South Texas Project Electric Generating Station P.O. Box 289 Wadsworth, Texas 77483

May 23, 2002
NOC-AE-02001246
10CFR50.90

South Texas Project
Units 1 and 2
Docket Nos. STN 50-498, STN 50-499
License Amendment Request
Proposed Revision to Relocate Shutdown Margin Limits From the
Technical Specifications to the Core Operating Limits Report And to
Modify Action Statements Consistent with NUREG-1431

FIGURE 3.1-1

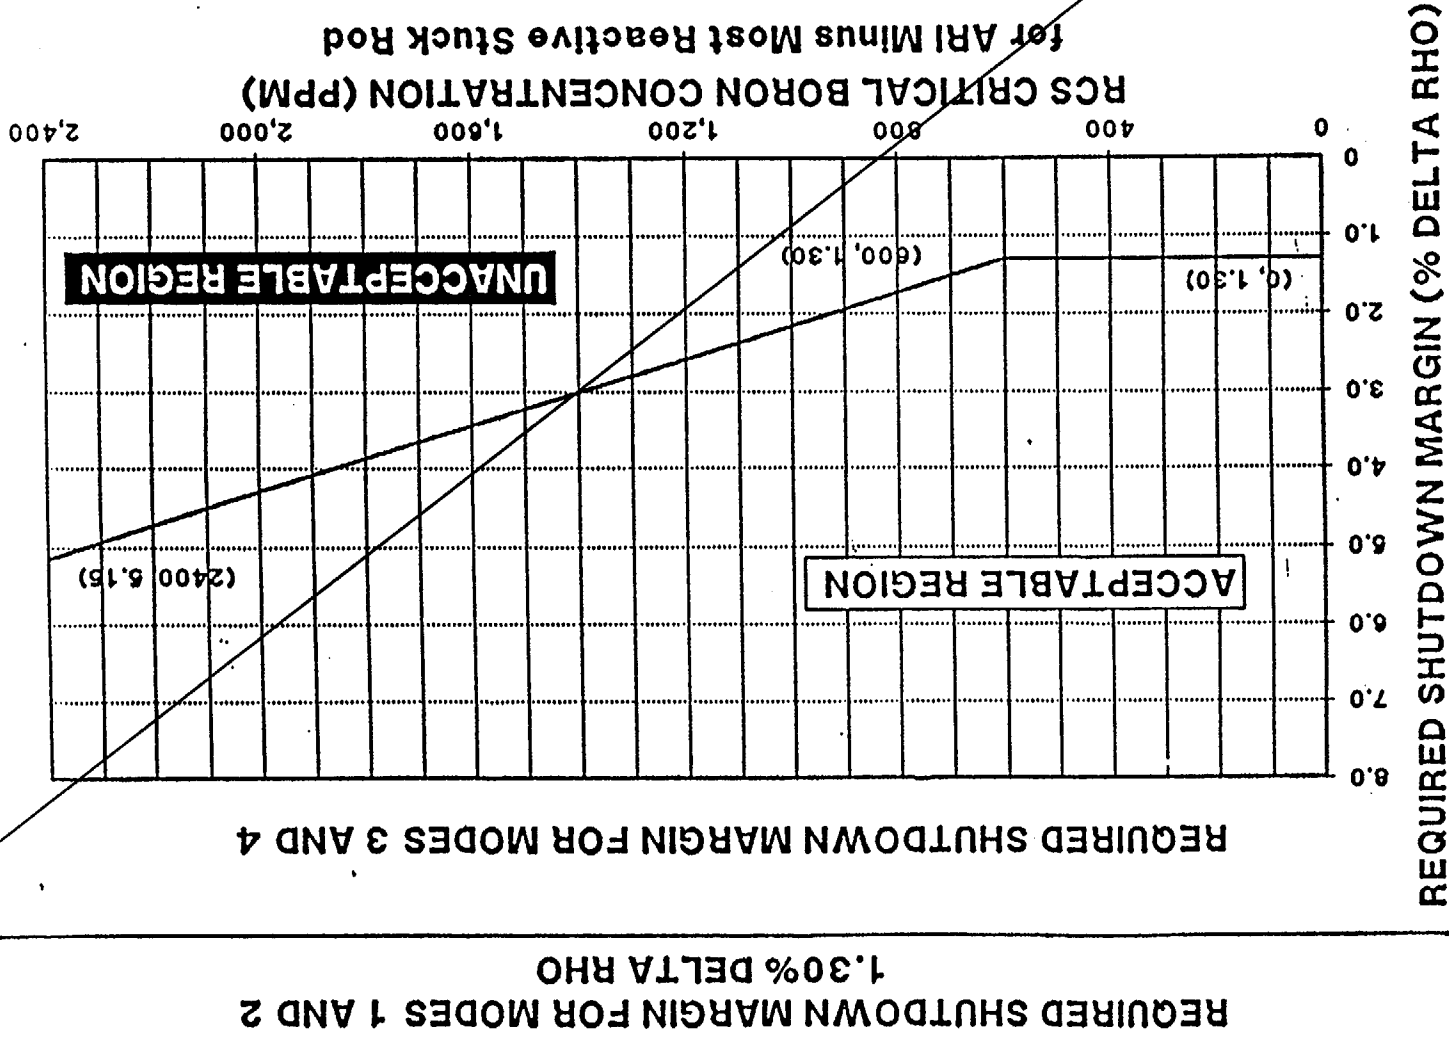
9	3/4 1-3	Figure 3.1-1	Delete Figure 3.1-1, the Required SHUTDOWN MARGIN limits will be included in the COLR.	See Item 1 above. The SHUTDOWN MARGIN limits in Figure 3.1-1 will be specified in the COLR.
10	3/4 1-4 3/4 1-5	3.1.1.2 LCO 3.1.1.2 Action SR 4.1.1.2 a & b Figure 3.1-2	Delete TS 3/4.1.1.2 LCO, Action and, Surveillance Requirements. TS 3/4.1.1.2 is combined with TS 3/4.1.1.1.	The LCOs, Actions and Surveillances are the same. This change combines the two Specifications and their applicability to make one SHUTDOWN MARGIN Specification. Figure 3.1-2 will be included in the COLR. The associated Bases will be revised to reflect these changes. This change is consistent with TSTF-136 and NUREG-1431. See Item 3 and 8 above.
11	3/4 9-1	3.9.1 Action	Delete specific values for boration flow and concentration in the ACTION statement.	The details for restoring boron concentration are informative, but the requirement of the specification is to maintain the specific reactivity conditions for refueling operations. Thus, these procedural details are not necessary for inclusion within the TS. This type of detail is included in plant procedures which provides

Relocated to COLR

FIGURE 3.1-2

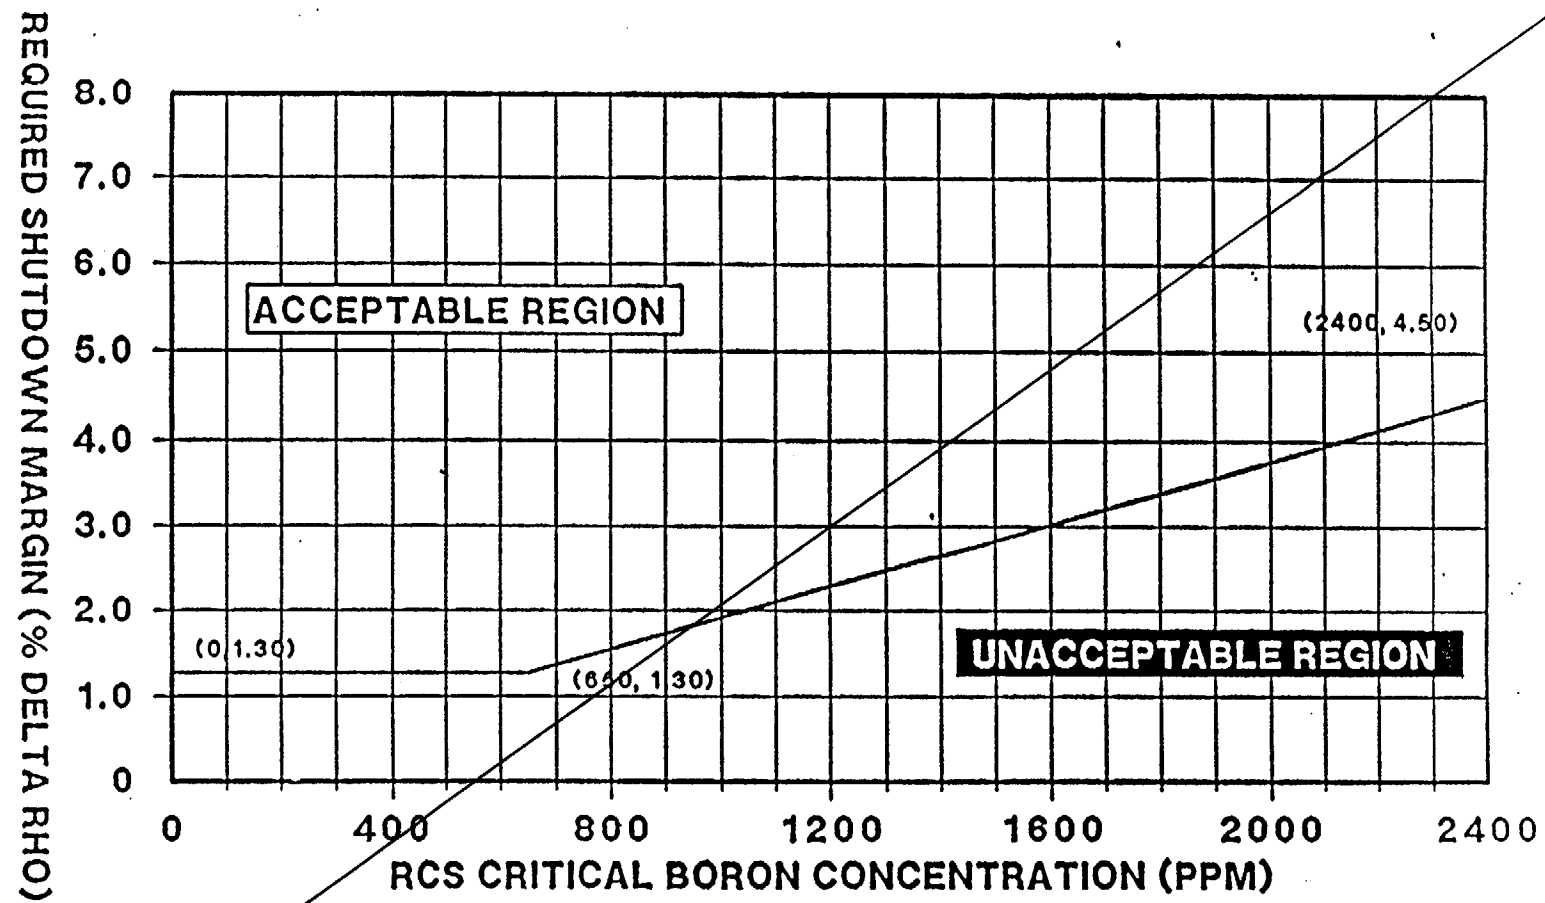
3.1.1.2 (This specification not used) The SHUTDOWN MARGIN shall be greater than or equal to the limit as shown in Figure 3.1-2.

Relocated to COR

Figure 2

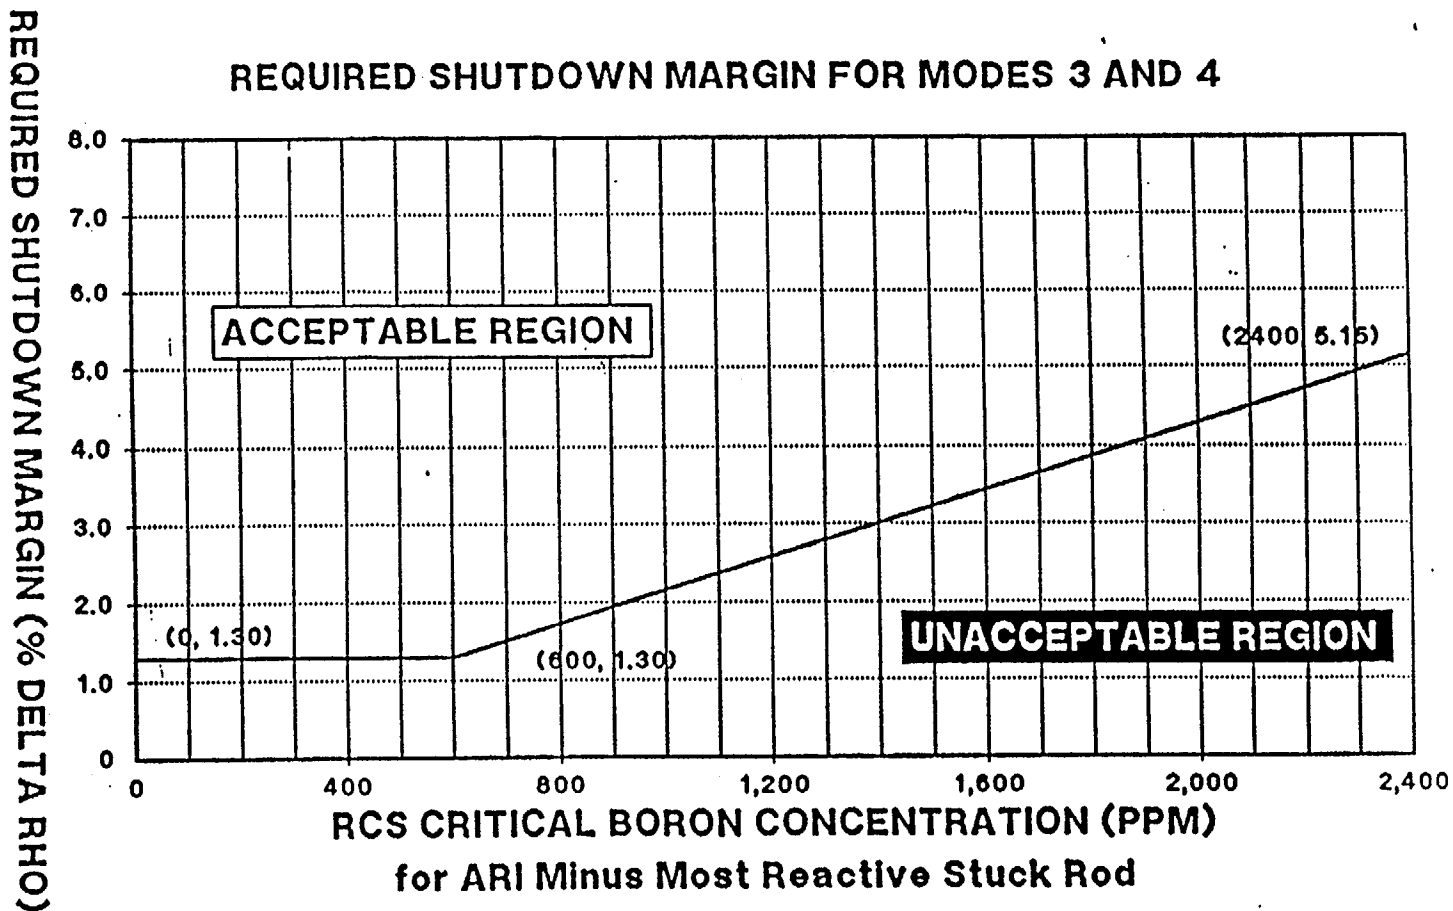
~~REQUIRED SHUTDOWN MARGIN FOR MODES 1 AND 2~~
~~1.30% DELTA RHO~~

~~FIGURE 3.1-1~~

2.3.2 Greater than the limits in Figure 2 for MODES 3 and 4

Figure 3

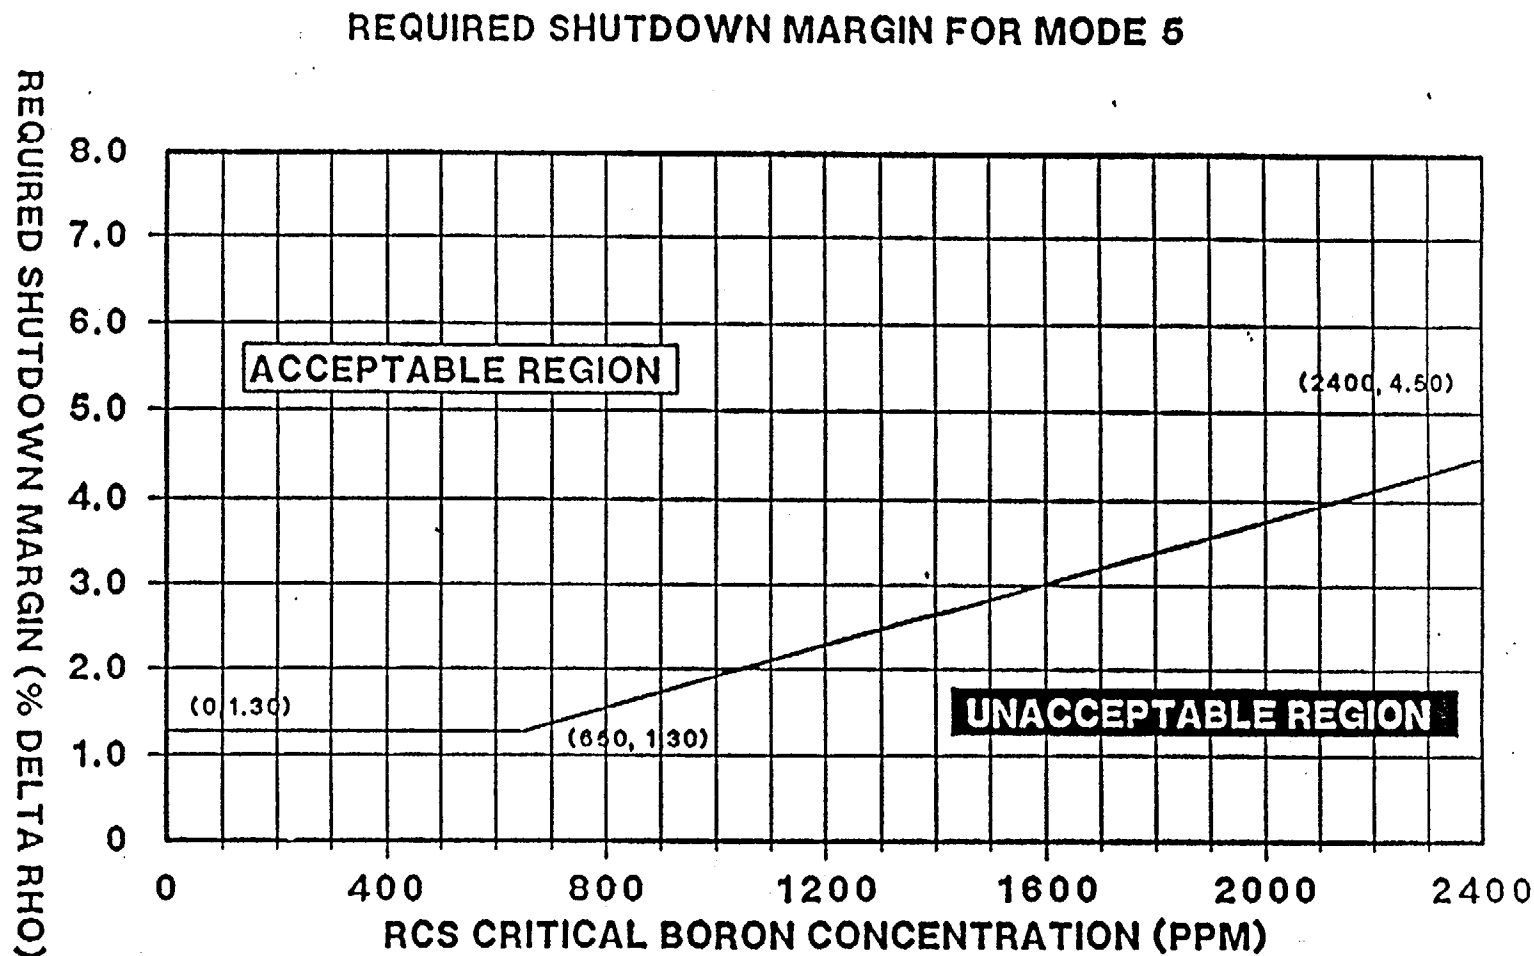
FIGURE 3.1-2

2.3.3 Greater than the limits in Figure 3 for MODE 5.
